# AGENDA

PLANNING AND ZONING COMMISSION WORK SESSION MEETING  
CITY HALL, 385 SOUTH GOLIAD STREET, ROCKWALL, TEXAS  
MAY 28, 2024 IN THE CITY COUNCIL CHAMBERS AT 6:00 PM

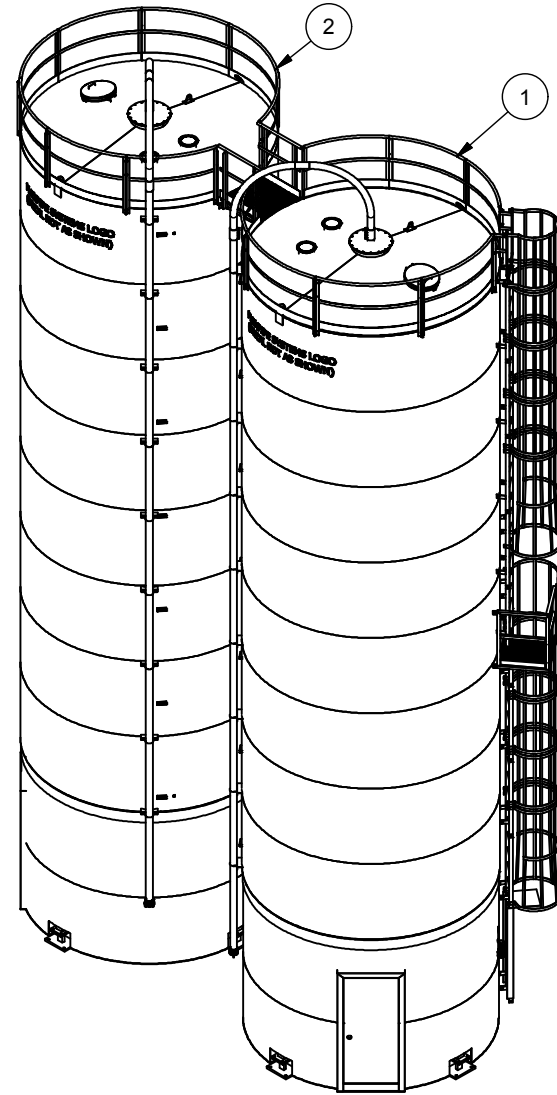
- Reviewed and accepted.
- Revise and resubmit.  
- Work may proceed.
- Revise and resubmit.  
- Work shall not proceed.
